RECEIVED
 NOV 17 2008
 APPROVED AS NOTED
 DATE 1/12/2010

Project: **DUMMERSTON BRIDGE**
 DUMMERSTON, VT

Date: 9-9-09
 Job No. 340142(28)
 Sheet No. GM1, GM2

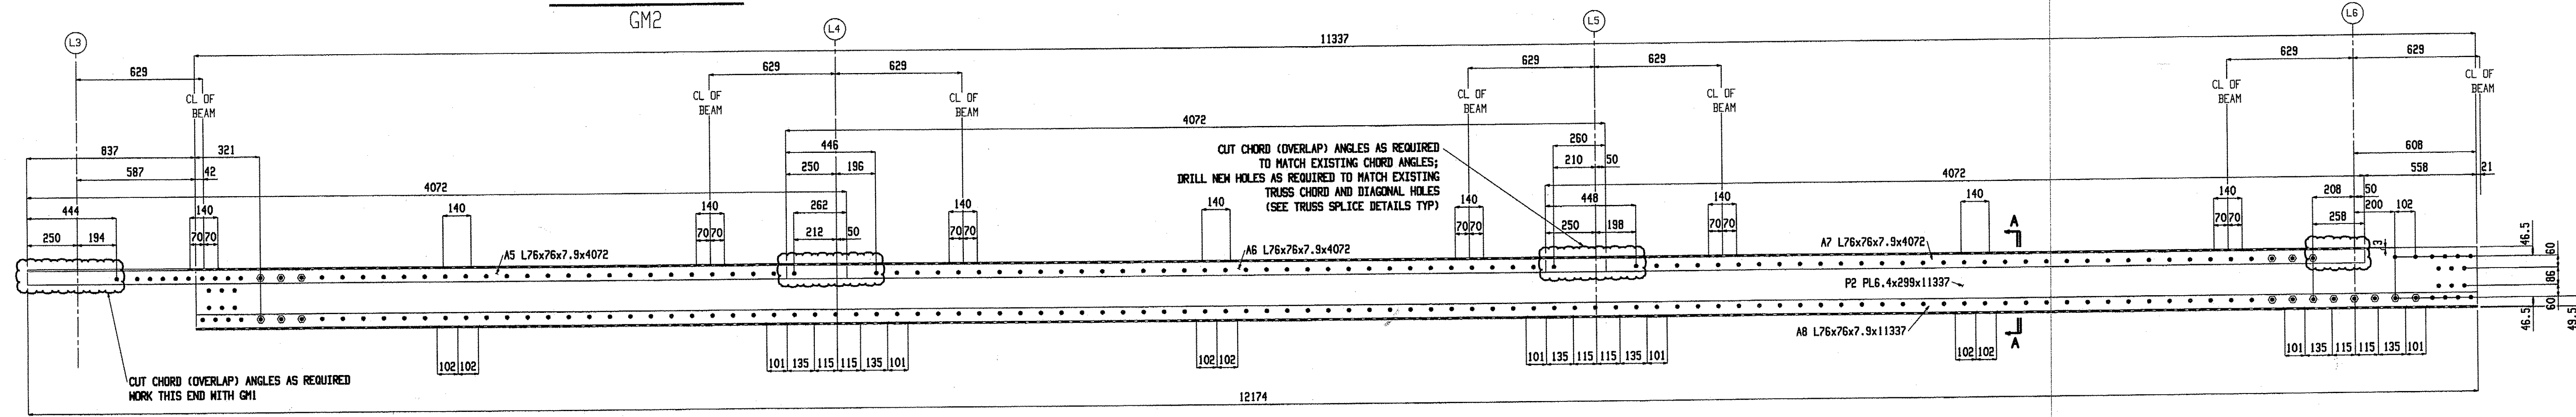
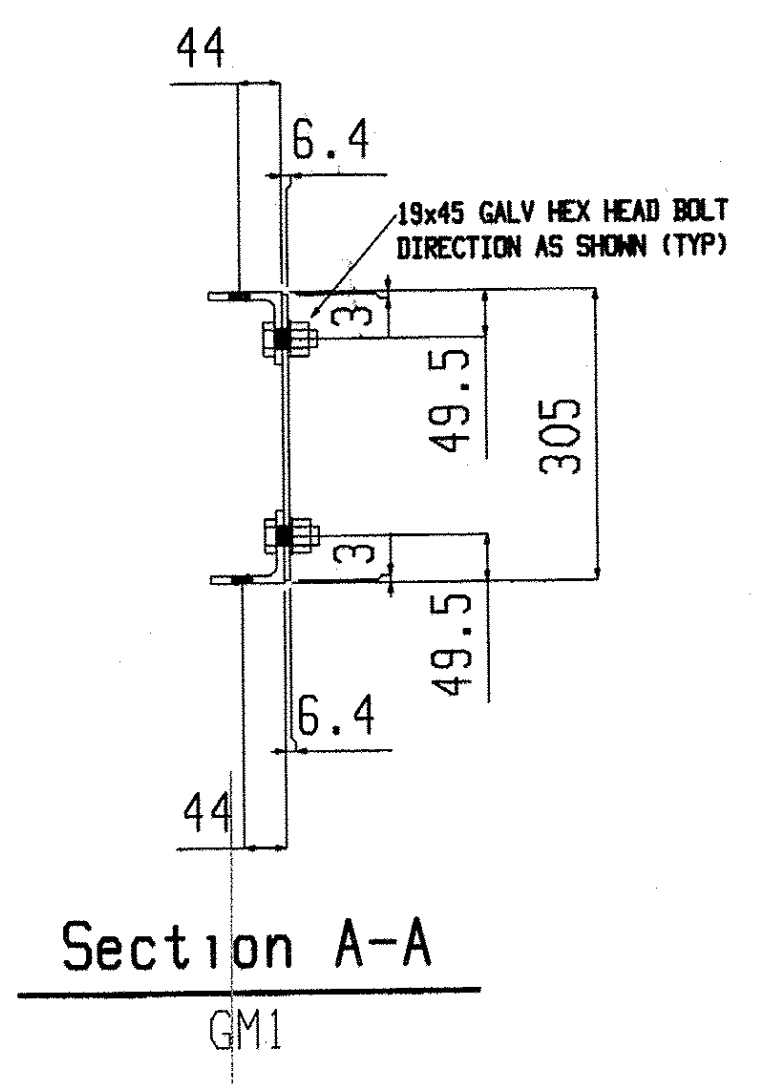
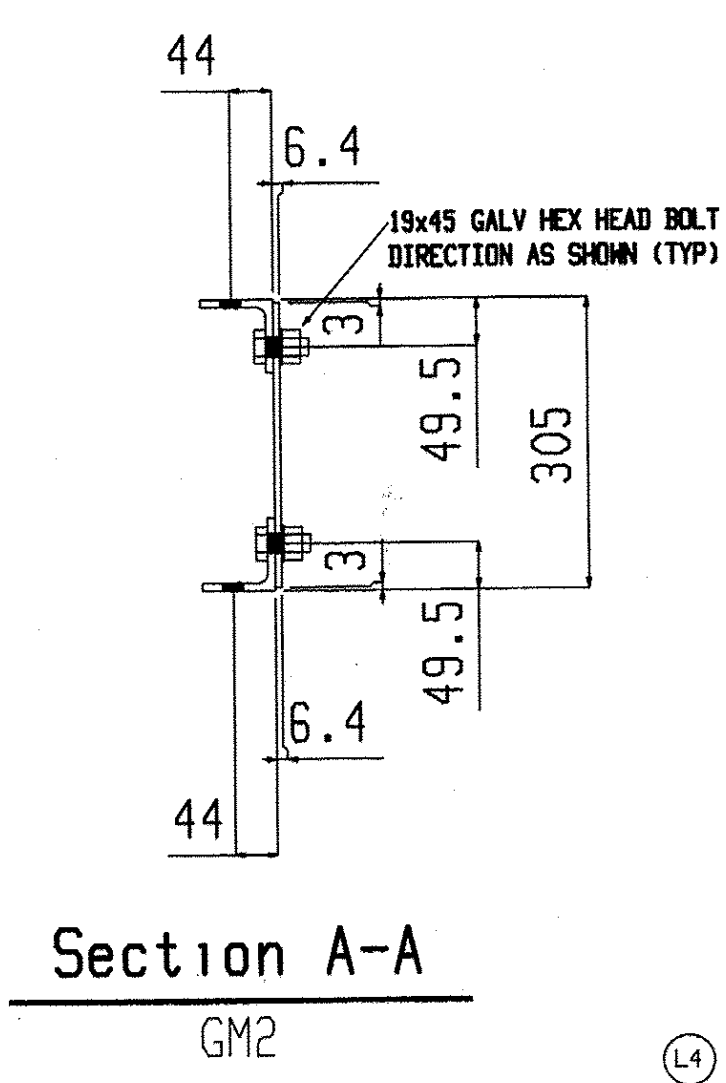
What paint system is being used?

These are parts numbers, not a sheet number.
